# Montgomery County Historic Preservation

## Staff Report

<p><b>ADDRESS:</b> 7411 Baltimore Avenue, Takoma Park</p> <p><b>RESOURCE:</b> Takoma Park Historic District</p> <p><b>APPLICANT:</b> Isabelle and Andy Hasty; (Paul Treseder, Architect)</p> <p><b>REVIEW:</b> HAWP</p> <p><b>CASE NO.</b> 1145605 REVISION</p> <p><b>PROPOSAL:</b> Alterations to previously-approved fenestration</p>	<p><b>MEETING DATE:</b> 5/13/2026</p> <p><b>REPORT DATE:</b> 5/6/2026</p> <p><b>PUBLIC NOTICE:</b> 4/29/2026</p> <p><b>TAX CREDIT ELIGIBLE:</b> No</p> <p><b>STAFF:</b> Devon Murtha</p>
---	--

Figure 2: Partial approved (left) and proposed (right) left elevation. Alterations are indicated in yellow.

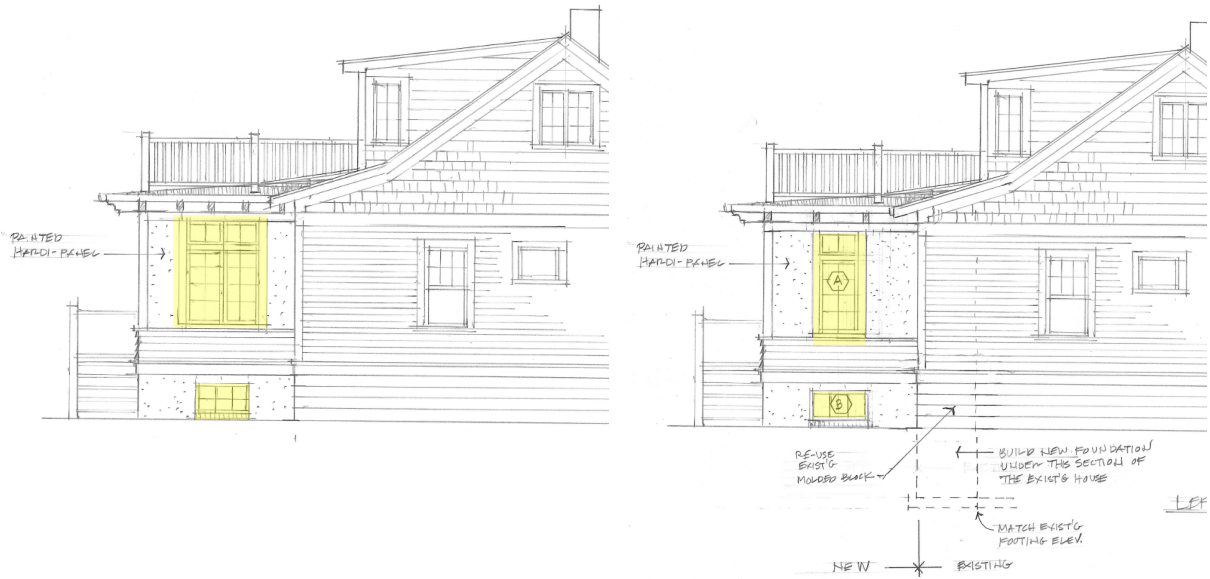
The applicant returned with a proposal to include minor fenestration alterations on the left (north) side elevation. Additionally, the applicant is proposing a change of materials for the rear deck, from a wood porch with wood railings to PVC stairs and railings.

Staff is supportive of the proposal to modify the fenestration alterations from the previous approval. The fenestration alterations will be located on a non-historic addition and not be visible from the right-of-way. Per *Standard 2* and the *Guidelines*, there will be no impact on the historic character of the resource or any historic fabric.

Figure 4: Proposed rear elevation. Alterations indicated in yellow.

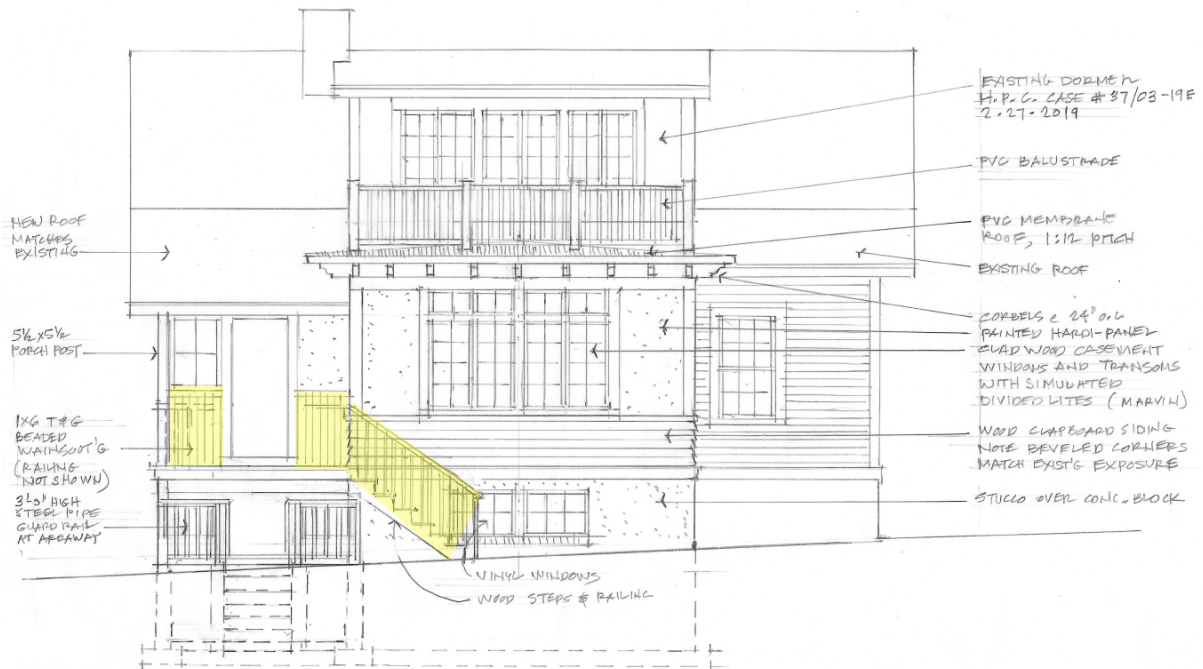
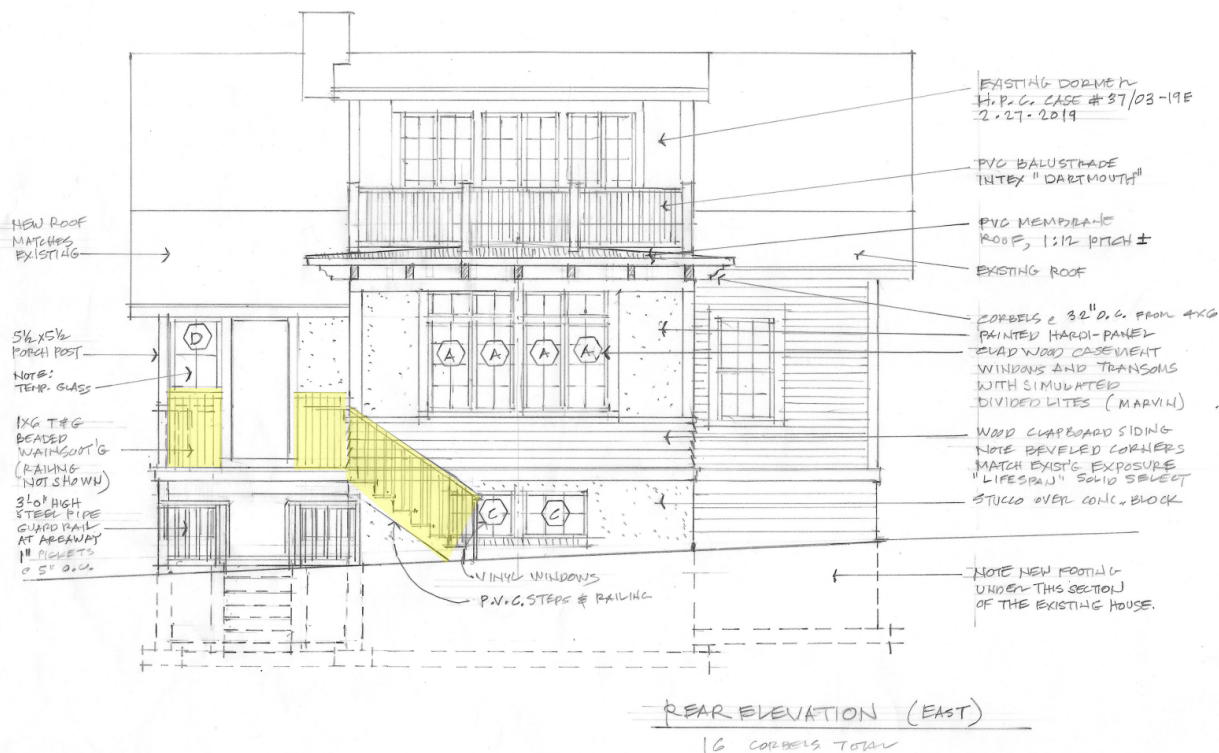
Staff does not have sufficient information to evaluate the change in material of the proposed rear deck railing from a wood railing to a PVC railing. In the previous Staff report for the February 11 HPC meeting, Staff wrote that “some of the proposed materials, such as the PVC trim and balustrades, are generally discouraged on alterations visible from the right-of-way; however, Staff finds that these will be minimally, or not at all, visible from the streetscape, and therefore will have no impact on the streetscape.” Staff finds that the rear deck *will* be more visible than the rear second floor deck, and is subject to a stricter review, per the *Guidelines* (*Figure 7*). Staff finds that unpainted PVC railings generally do not replicate the look of wood and are incompatible building material. Staff strongly recommends that the applicant install a wood railing in this location, but notes that a paintable PVC railing may be appropriate in this location given its setback. The applicant should return with material specifications for the railing that meet this criterion, with final approval delegated to Staff.

1. The applicant must submit comprehensive materials specifications prior to issuance of final approval documents, including specifications for all windows, trim elements, decking, rear PVC stairs, and detailed specifications for the proposed fiber cement siding to specify exposure depth.
2. The railings on the first story rear deck must be wood, or a paintable material that replicates the look of wood.
